# ULPOWER AERO ENGINES N.V.

## SERVICE BULLETIN

Service Bulletin No. 2015-01

SUBJECT: Alternator fan

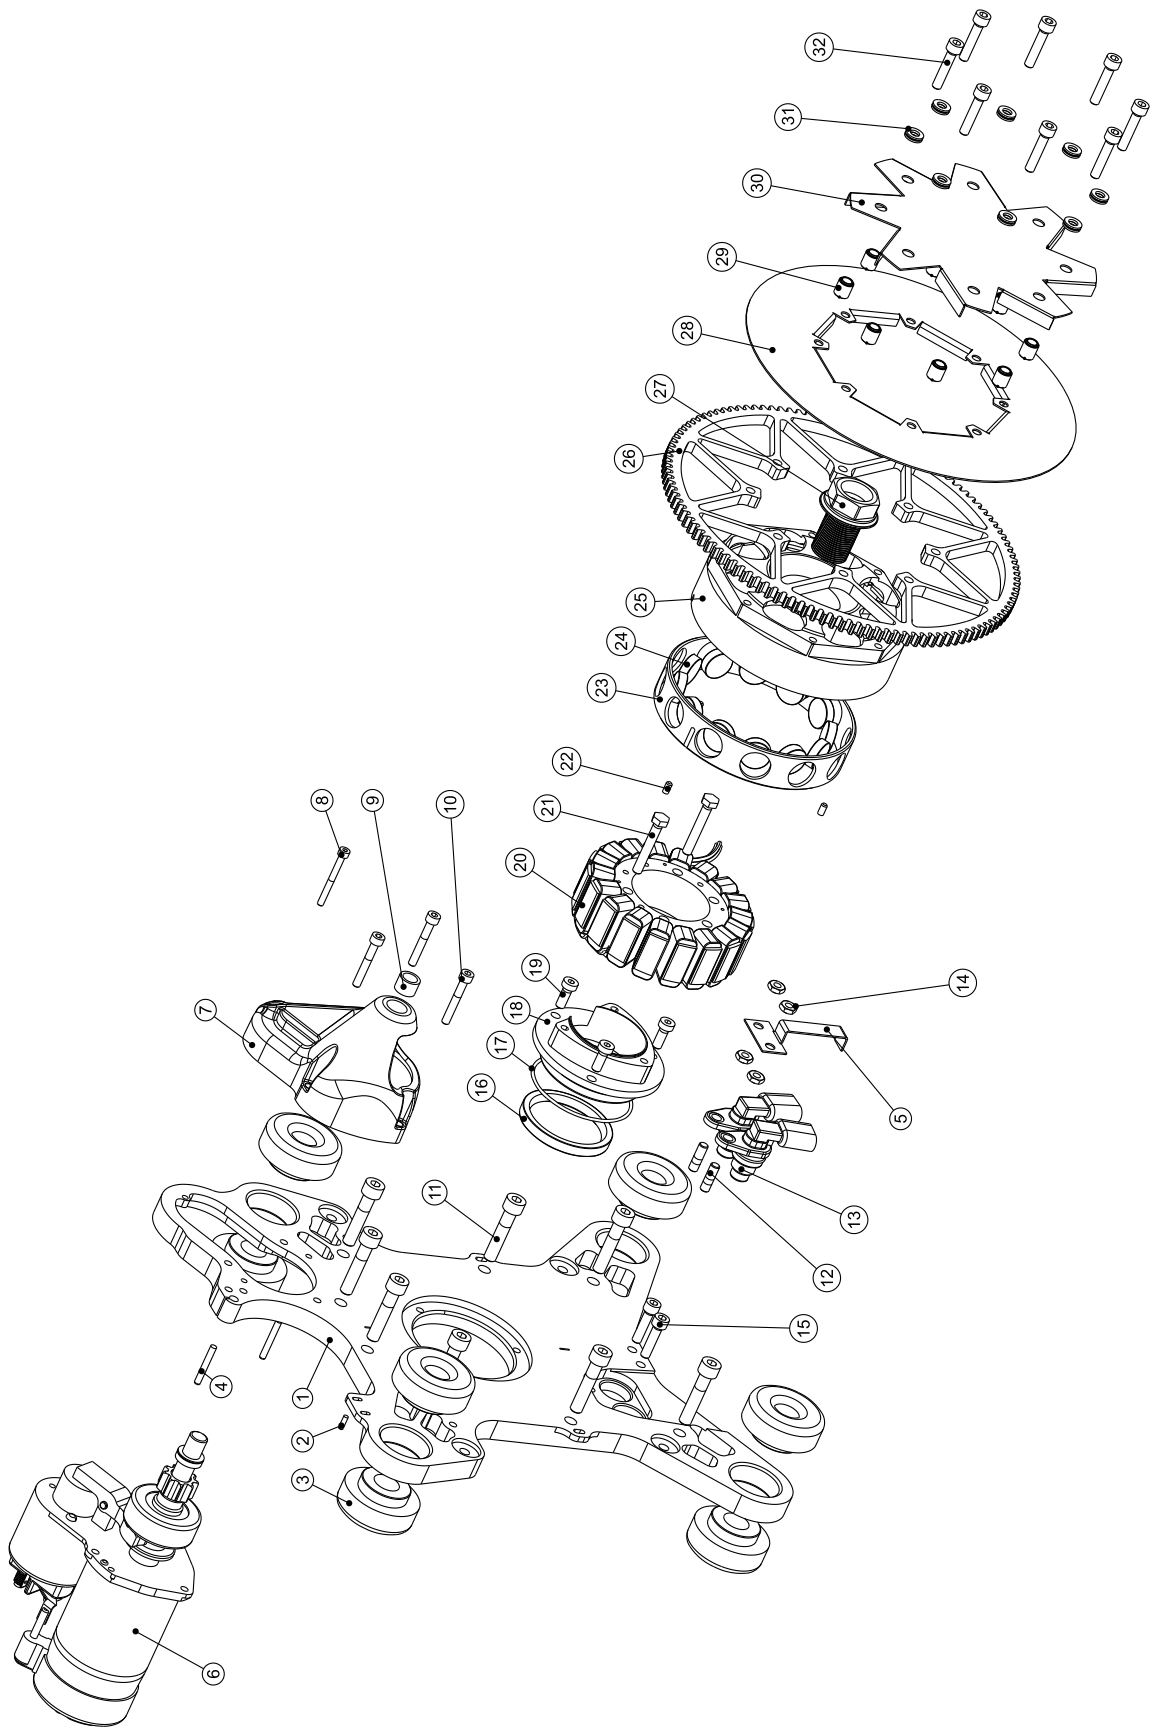
Problem the small fixation flaps (with Ø6 mm hole) might be cracked

Solution: Replace the old style alternator fan base by the new style alternator fan base .  
(no more flaps)

Unscrew 8 bolts n° 32

Remove the complete alternator fan (28 + 29 + 30)

Change part 28 old style fan base to new style fan base

Replace the complete alternator fan (28 new style + 29 +30)

Tighten the 8 bolts n°32 to 10Nm
